SUBJECT: **San Onofre Nuclear Generating Station, Units 2 and 3**
Docket Nos. 50-361 and 50-362
Additional Information Regarding
Proposed Change Number (PCN) 561
Degraded Voltage Setpoints

PCN 561 NRC Questions and SCE Responses

DGVSS/SDVS Logic Diagram

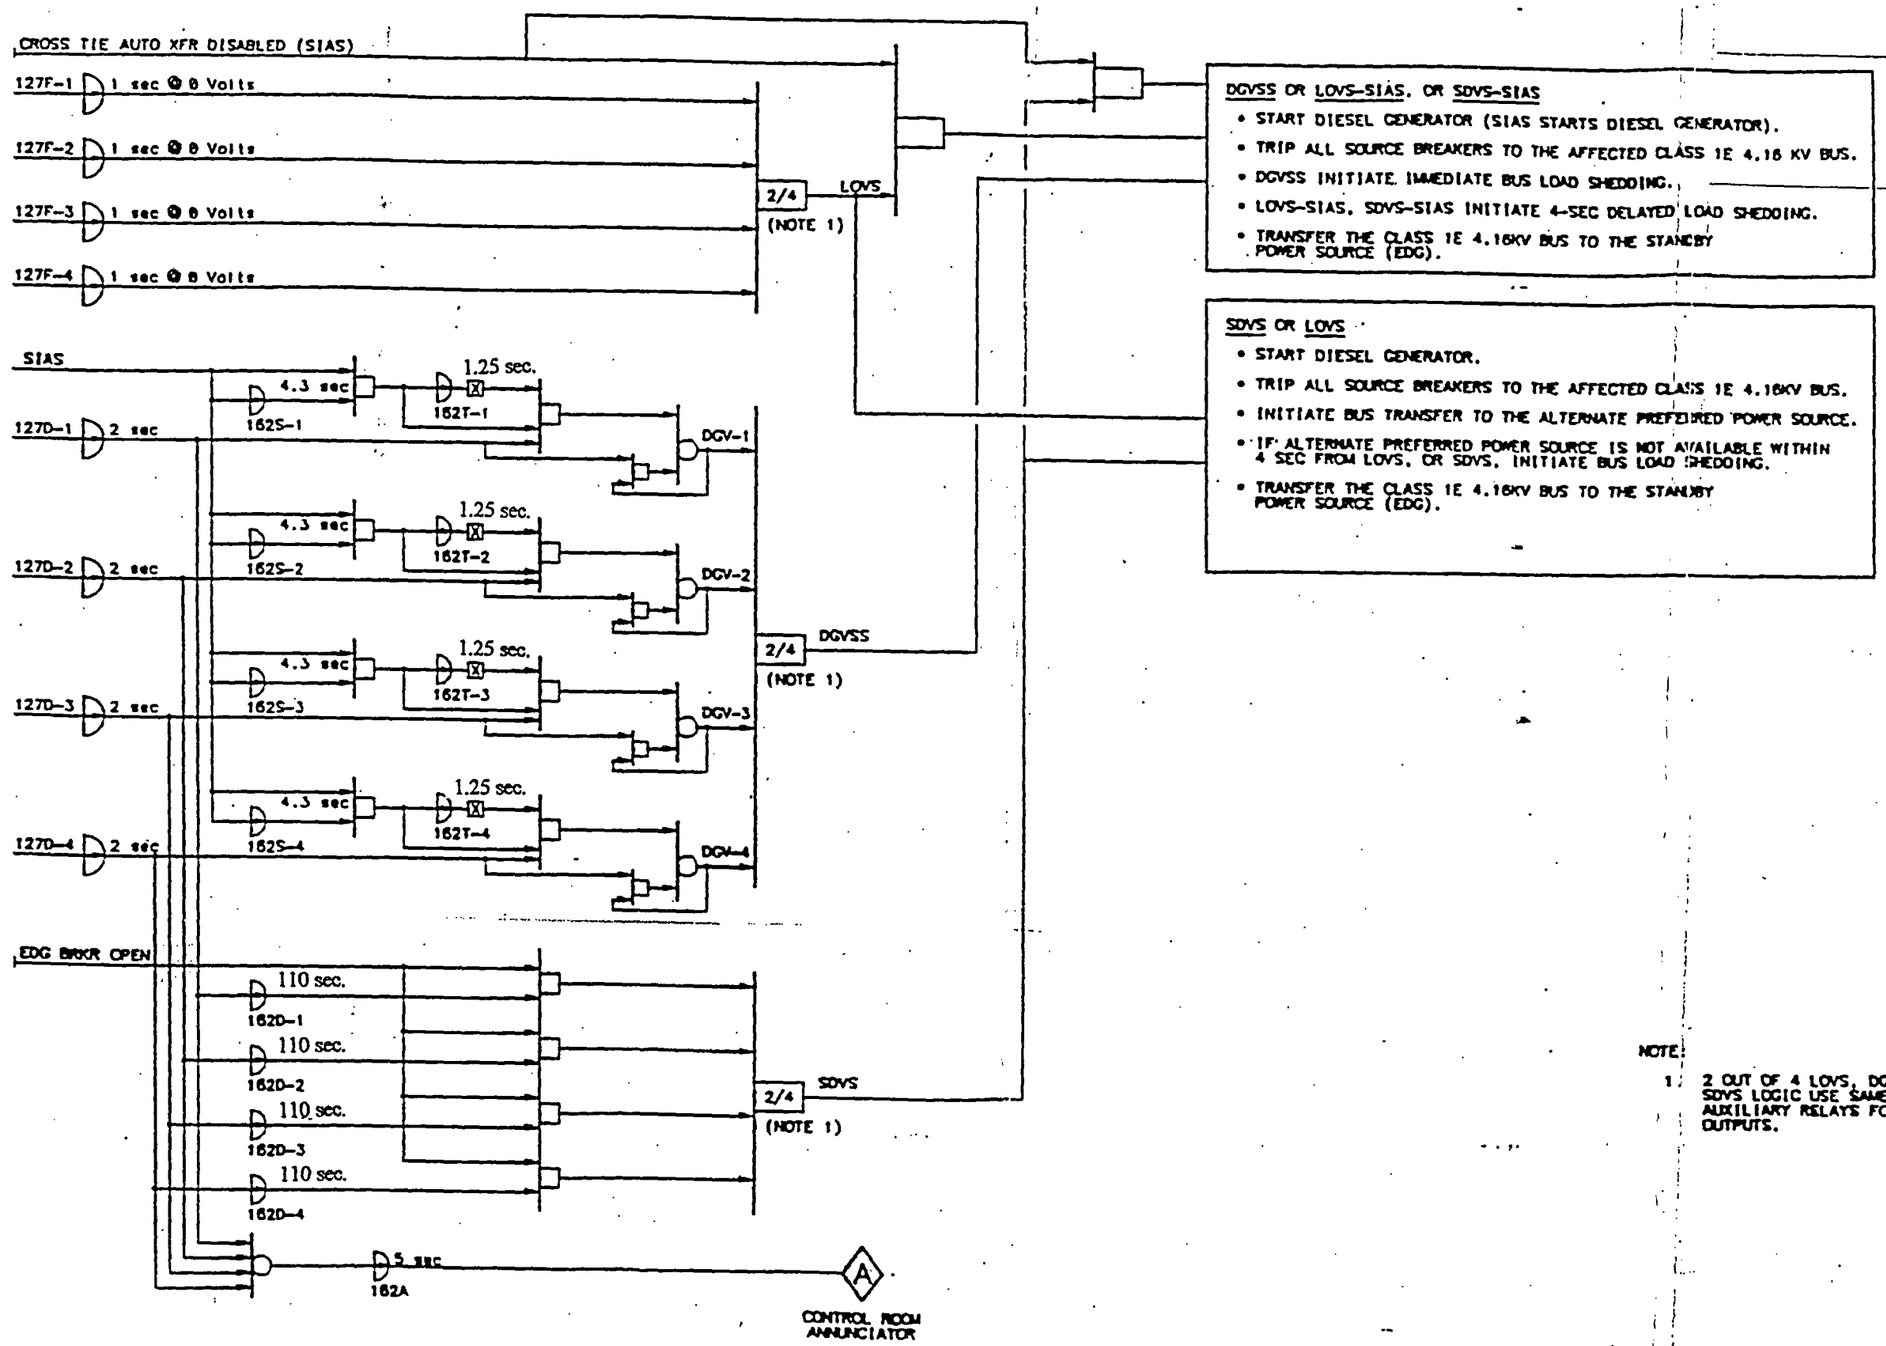
Discuss and provide the SDVS/DGVSS logic diagram from the design basis document (DBD), and also provide the schematic and E.D. for these relays.

SCE letter dated November 16, 1993 (Reference 1), Section 4.2.2, provided a detailed description of the Degraded Grid Voltage with SIAS Signal (DGVSS) and Sustained Degraded Voltage Signal (SDVS) schemes. An updated summary of this discussion was provided in SCE's letter dated May 27, 2005 (Reference 2), Section 3.0, "Background." Attachment 1 of this letter provides a logic diagram depicting the DGVSS/SDVS schemes. Attachment 2 of this letter provides an Elementary Diagram of the 4.16 kV Degraded Voltage Detection Scheme, Drawing 32220, Sheet 2.

The response to Question 8 and the DGVSS/SDVS Logic Diagram (Attachment 1) explain that the time delay 162S for DGVSS window opening time delay is started by SIAS and independent of time delay of the degraded grid relay. The Window opens if 162S relay & associated 127D have operated. The window is closed when time delay 162T operates. Thus the DGVSS window opens between 4.11 and 4.49 seconds (4.3 +/- 0.19 sec) and closes between 4.96 and 6.14 sec from initiation of SIAS. All motor loads that were running or started in load group 1 will be tripped if the DGVSS is initiated. Following initiation of a DGVSS, there is an additional time delay of 2.0 ± 0.20 sec. provided for breaker tripping and decaying of voltage at the loads prior to re-energizing. Following the 2 second time delay, the EDG breaker will close provided the bus voltage has decayed to 25% (detected by 127R relays) and the EDG has attained normal voltage and speed. Then the loads of load group 1 will restart and all other loads will start in proper sequence.
